COMMENT #110

Limit for Cable Assembly ERL

Bruce Champion, TE

ERL Draft Comparisons

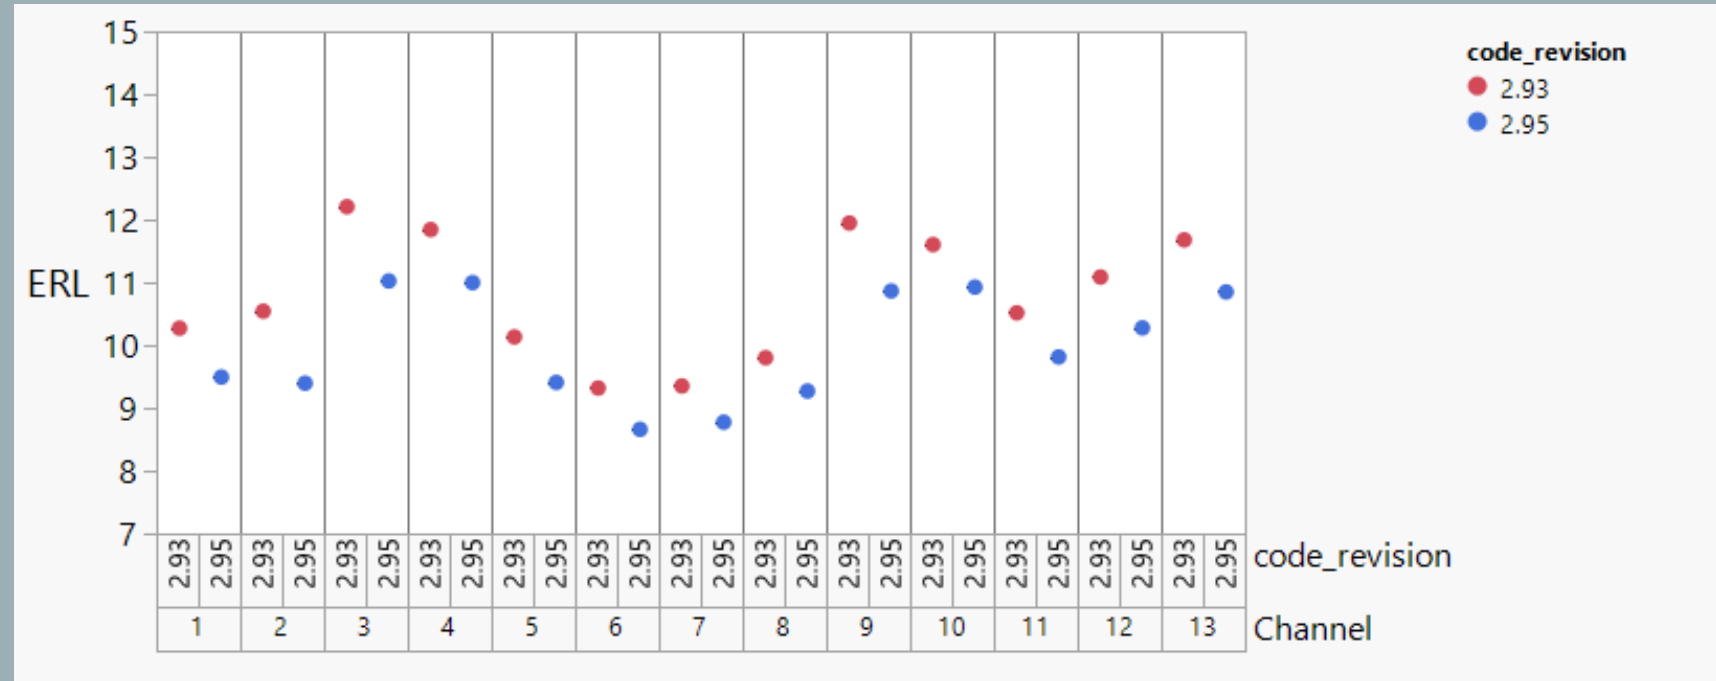
- Draft 1.2 and 1.3 use different approach to ERL

- 13 channels compared
- Data represents T_{p1} - T_{p4} measurements
- All channels have $-19.5 < IL < -19.75$ dB
- Changing to fixed fixture delay time, $N_{bx}=0$, and tukey window reduced ERL numbers by an average of 0.81 dB

Proposed Limit

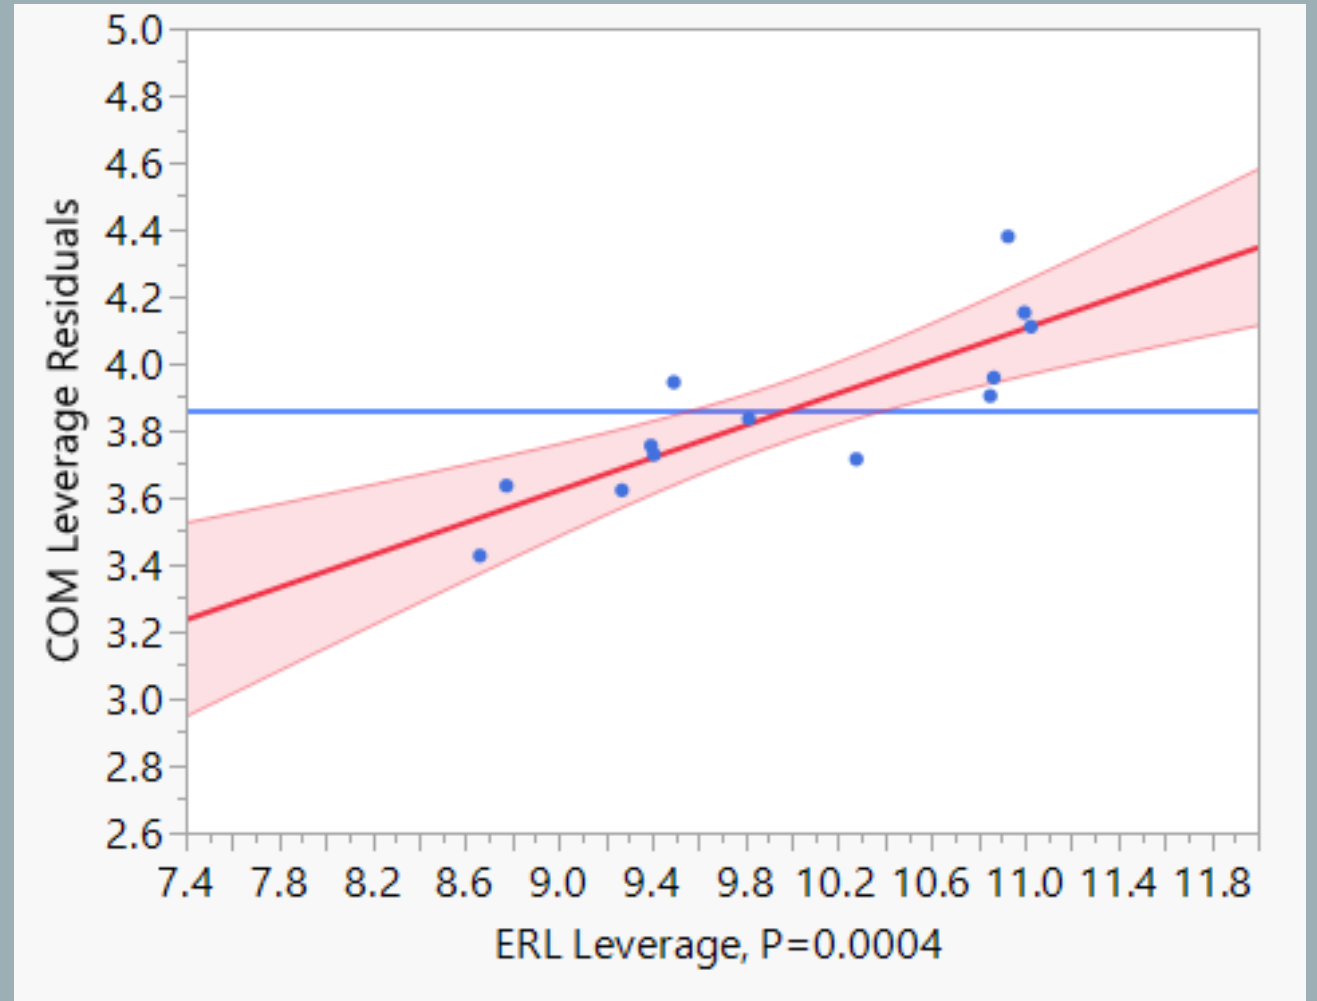
- Same 13 channels from previous slide used
- Relationship between ERL and COM observed
- The linear fit of data is showing:
 - COM = 3 dB at ERL = 6.4 dB
- Looking at the confidence interval:
 - COM = 3 dB at ERL \approx 7.4 dB
 - Using this data, a limit of 7.4 dB for ERL is proposed

CI 162 SC 162.11 P 156 L 37 # 110
 Champion, Bruce TE Connectivity
 Comment Type T Comment Status D ERL value
 Cable Assembly ERL listed as TBD in Table 162-16
 SuggestedRemedy
 TBD to be changed to 7.4 dB. See presentation
 Proposed Response Response Status W
 PROPOSED ACCEPT IN PRINCIPLE.
 [Editor's note: Addresses incomplete specification.]
 Resolve using the respose to comment #114.
